Environmental Assessment Addendum

Replacement Flows Project
Operational Noise Criteria – CoA 2.17 & 2.18

October 2010

**Modification to CoA 2.17 and 2.18
AWTP Site, St Marys**

Figure 2 – Mitigation Measures required at AWTP to meet CoA 2.17 & 2.18 requirements

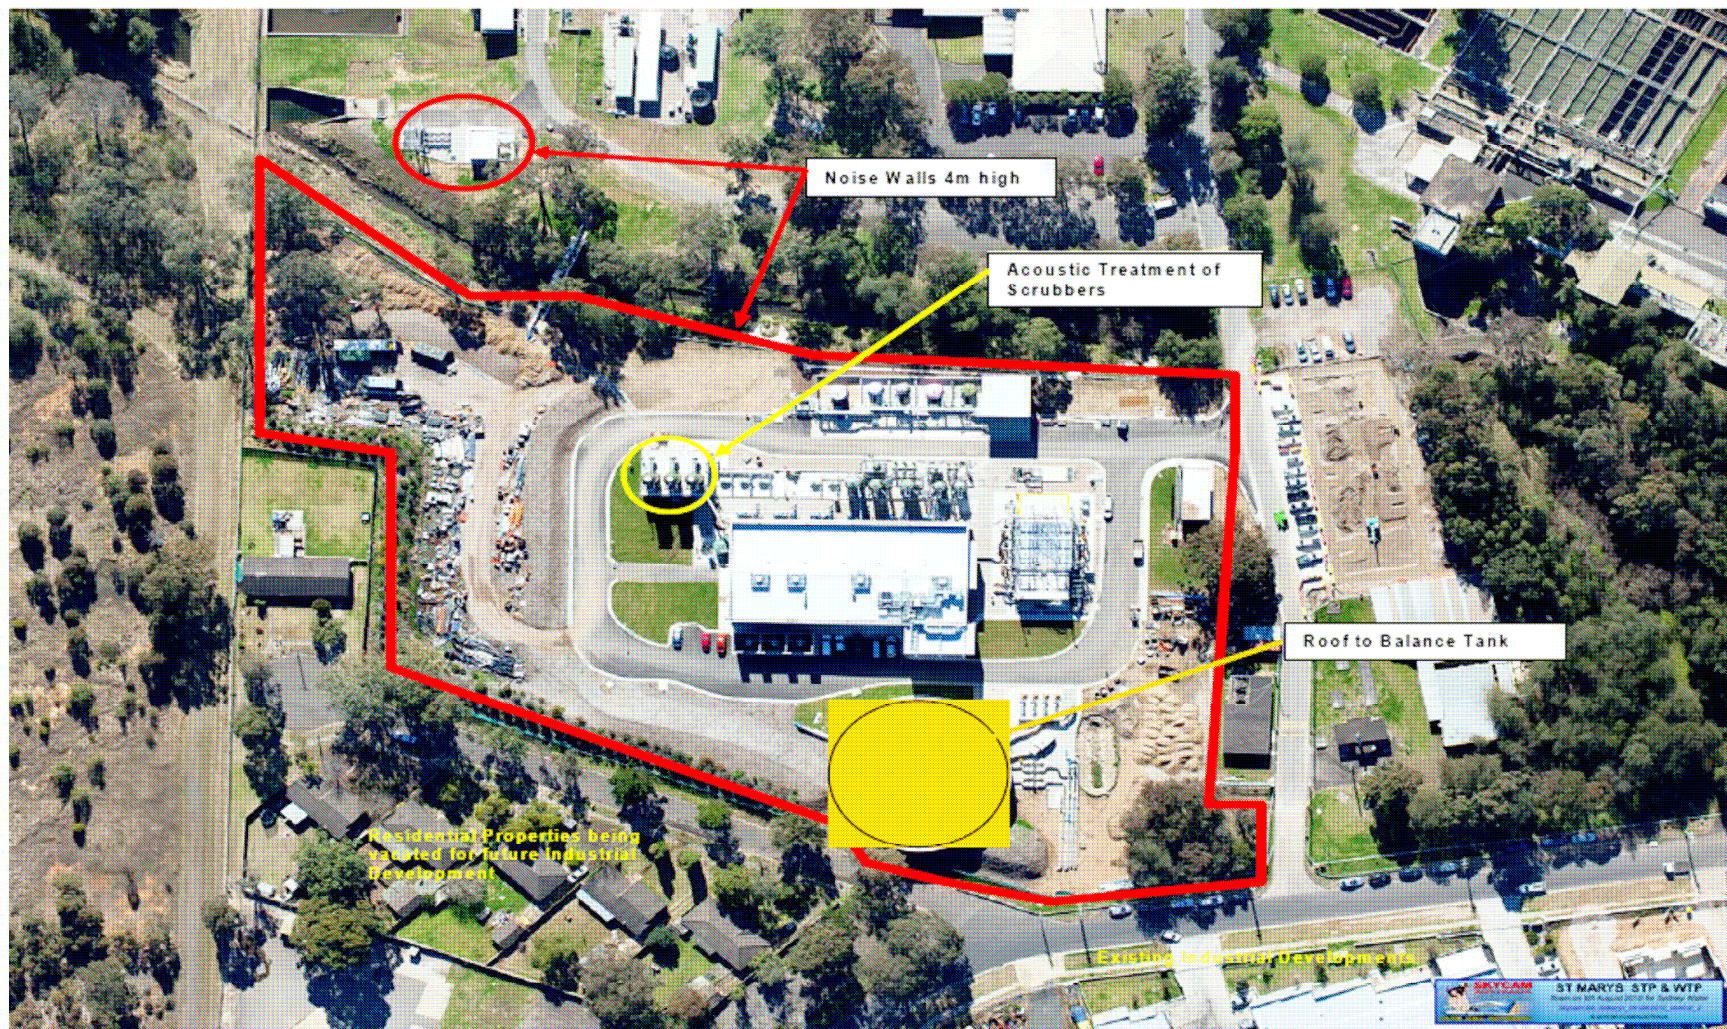
The technical memo is attached in **Appendix A**. The memo concludes that significant noise mitigation would be required at the AWTP site to meet the requirements of CoA 2.7, including:

- Acoustic treatment of the scrubbers using attenuators
- A concrete lid on the balance tank
- A 4m high, 800m long noise wall around the entire AWTP site and new pumping station site.

Figure 2 shows where these mitigation measures would be required.

- It would be feasible to install the mitigation measures. However, the earth mound around the AWTP would need to be removed to allow the installation of the noise wall around the AWTP and the AWTP would need to be shut-down during the construction of the lid on the balance tank and installation of the attenuators

- The installation of the mitigation measures would not be reasonable because:
 - no sensitive receivers (residents) would benefit and there would be minimal (if any) benefit for the surrounding industrial receivers

- the cost of the mitigation would far outweigh any benefits provided
 - the noise levels associated with the AWTP (without the mitigation measures) would comply with the INP criteria for the surrounding industrial receivers (an "Acceptable" level of 70dBA)

- the removal of the existing noise mound would have short-term traffic and access impacts on the surrounding industrial/commercial area users
 - the new 4m high noise wall around the AWTP site would have a long-term visual impact

Should the requested modification to CoA 2.17 & 2.18 be approved by the Director-General, Sydney Water would undertake operational noise monitoring (in accordance with CoA 3.2) at the nearest privately owned residential receivers. Monitoring would determine if there are increases in noise levels above the noise levels emitted from the sites prior to construction, ***as measured at the nearest sensitive receivers***. If increases in noise levels are found, mitigation measures would then be adopted to meet the requirements of CoA 2.17 and 3.3.

- Sydney Water could effectively target expenditure on beneficial mitigation measures for sensitive receivers if the operational monitoring finds increases in noise levels at the nearest sensitive receiver locations above the noise levels emitted from the sites prior to construction
- Sydney Water would avoid the considerable cost (\$2.5M) of mitigating noise at the AWTP site that would be of little or no benefit to the local, industrial community
- the inconvenience and impacts associated with removing the vegetated earth mound around the AWTP and shutting the AWTP down during the installation of the new noise mitigation measures would be avoided
- the long-term visual impact of the 4m high noise wall around the AWTP would be avoided.

Figure 1 Site Layout and Measurement Positions

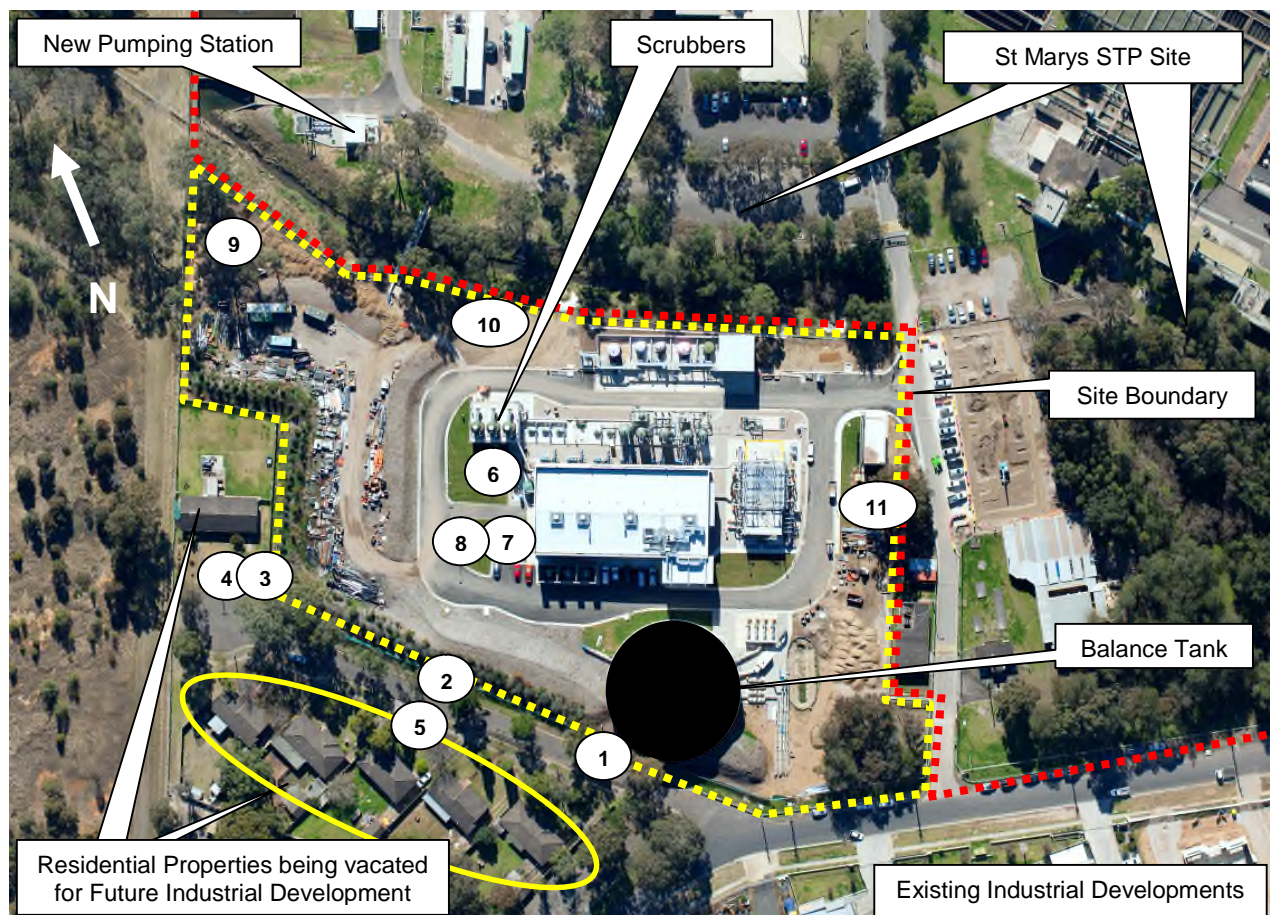
The measurements positions are shown in **Figure 1**, and the measured levels are shown in **Table 2**.

Table 2 shows exceedances of 7 dBA to 11 dBA above the pre-existing background noise of 40 dBA (ie, levels in the order of 47 dBA to 51 dBA) on the southern boundary, which is adjacent to existing and future industrial areas.

At the northern and eastern boundaries, **Table 2** shows exceedances of 13 and 24 dBA due to noise from the Scrubbers. However these are internal boundaries to the St Marys STP site, which is a SWC asset (**Section 2.1.1** refers). It should be noted that the measured levels of all boundaries (**Table 2**) comply with the INP Industrial Criteria (70 dBA).
